REGULATION No. 125  
(Forward field of vision of drivers)

Proposal for draft amendments to Regulation No. 125

Note: The text reproduced below was prepared by the expert from OICA to improve the French working document ECE/TRANS/WP.29/GRSG/2009/20. The modifications to the **current** text of the Regulation are marked in bold or strikethrough characters.

"Figure 7: Definition of the area 'S' (paragraph 5.1.3.2.)

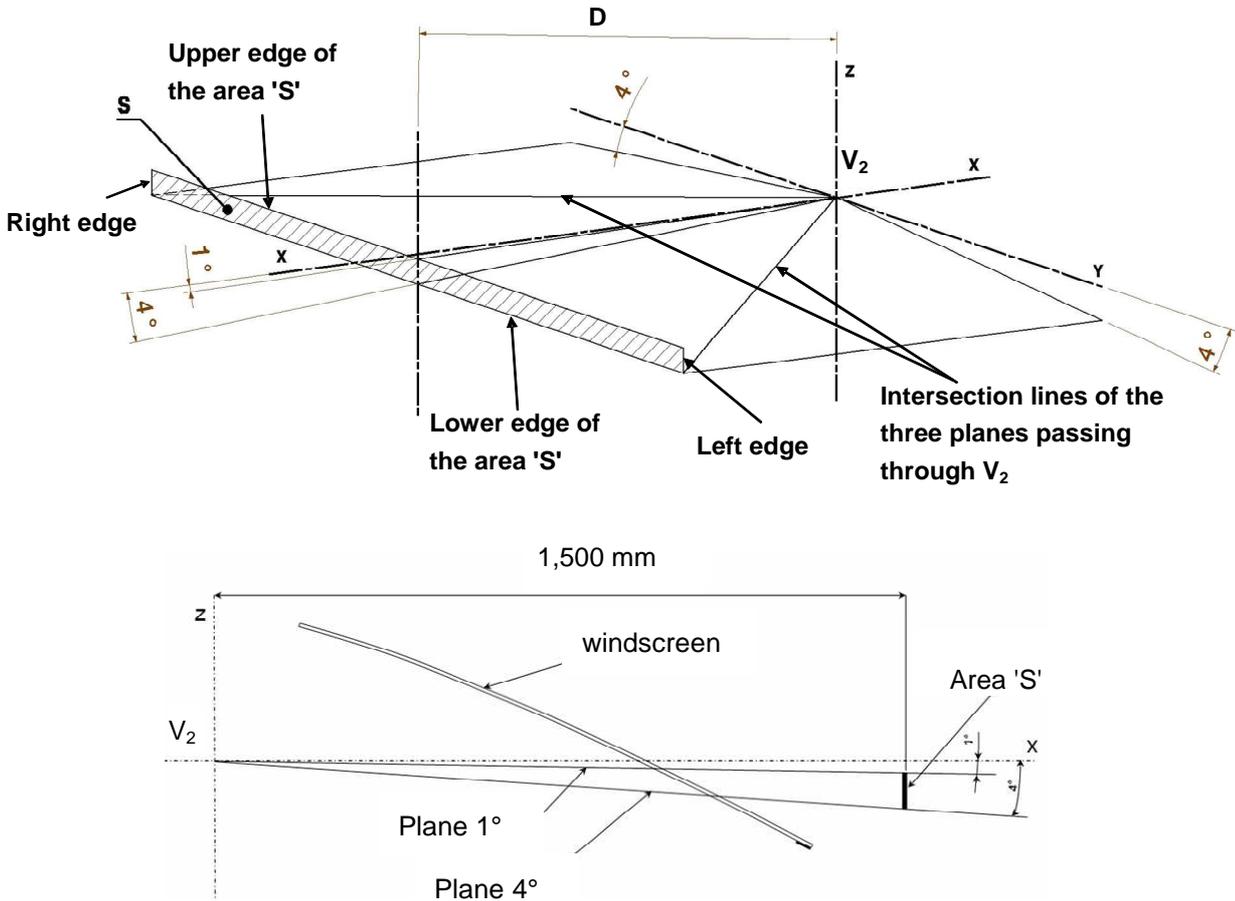
"5.1.3.2. **An obstruction between a plane through V<sub>2</sub>, and declined at least 1° below the horizontal and a plane through V<sub>2</sub> and declined 4° below the horizontal will be tolerated if the conical projection of this obstruction, starting from V<sub>2</sub>, on an area 'S' as defined in paragraph 5.1.3.2.1 does not exceed 20 per cent of this area. The steering wheel, if adjustable, shall be placed in the normal position indicated by the manufacturer or, failing that, midway between the limits of its range(s) of adjustment.**"

"5.1.3.2.1 The area 'S' (see Annex 4, Appendix, figure 7) is a rectangular vertical area located in a plane perpendicular to the X coordinate 1,500 mm forward of the point V<sub>2</sub>. The upper edge of the area 'S' is defined by a plane passing through V<sub>2</sub> declined forward 1° below the horizontal. The lower edge of the area 'S' is defined by a plane passing through V<sub>2</sub> declined forward 4° below the horizontal. The left and right edges of the area 'S' are vertical and generated from the intersection lines of the three planes declined 4° as defined in paragraph 5.1.2.2. above.

5.1.3.2.2 In the case of a windscreen extending beyond 1,500 mm forward of the point V<sub>2</sub>, the distance between the area 'S' and the point V<sub>2</sub> may be extended accordingly."

Annex 4, Appendix, insert a new figure 7, to read:
